# Service Bulletin No. 361

MODEL <b>D Series Coaches</b>	TYPE <b>Field Change Program</b>	SECTION/GROUP <b>7 - Electrical</b>	DATE <b>Mar. 8, 2012</b>
SUBJECT <b>ELECTRONIC STABILITY CONTROL ( ESC ) TELL-TALE</b>			
CONDITIONS

**Figure 4.**

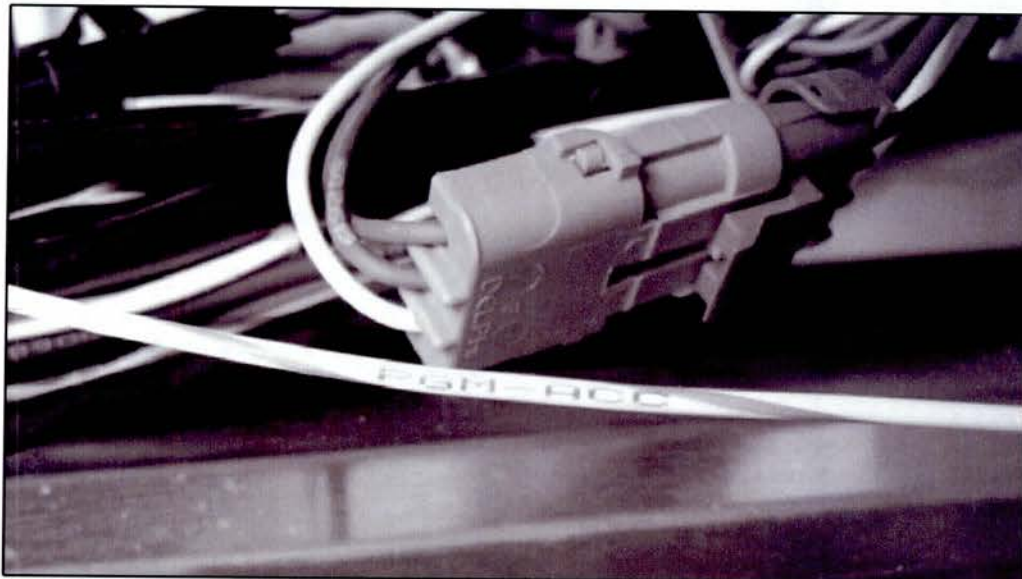
9. Locate the white/green tracer wire labeled PGM-ACC exiting the top connector from Pin 12 ( refer to Figure 4 ).
10. Cut any existing tytraps to unsecure the PGM-ACC wire for a distance of twenty two ( 22 inches ) ( refer to Figure 3 ).

**Figure 5.**

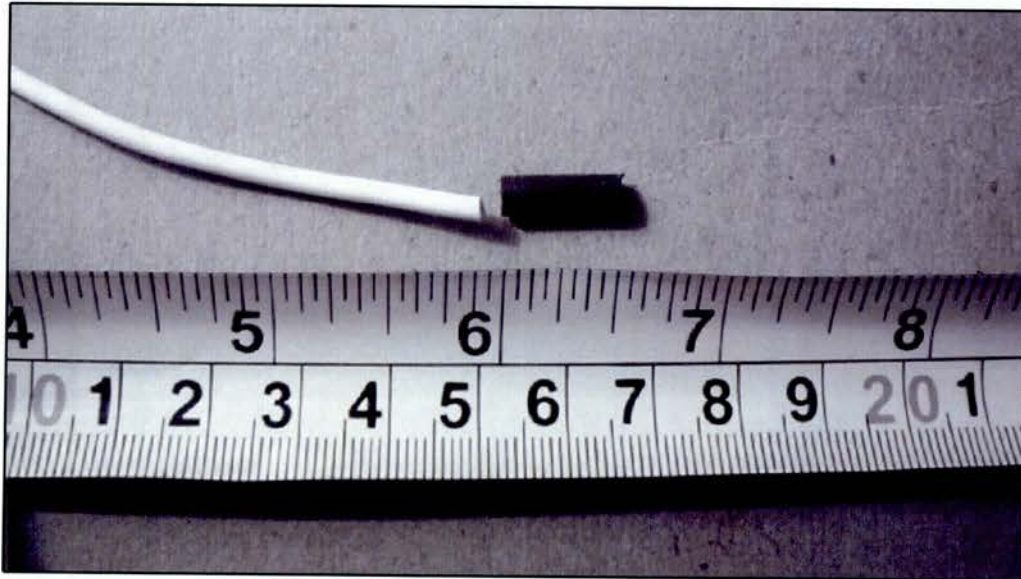
11. Using wire cutters, cut the wire. Using shrink wrap, terminate the end of the wire routed to the curbside of the coach.

12. Reroute the wire coming from the Gateway module towards the top connector on the Grounding Module and remove the connector and the end cap.
13. Install connector number 1062-16-0122 on to the end of the wire and install it into the top connector on Grounding Module in pin location #2.
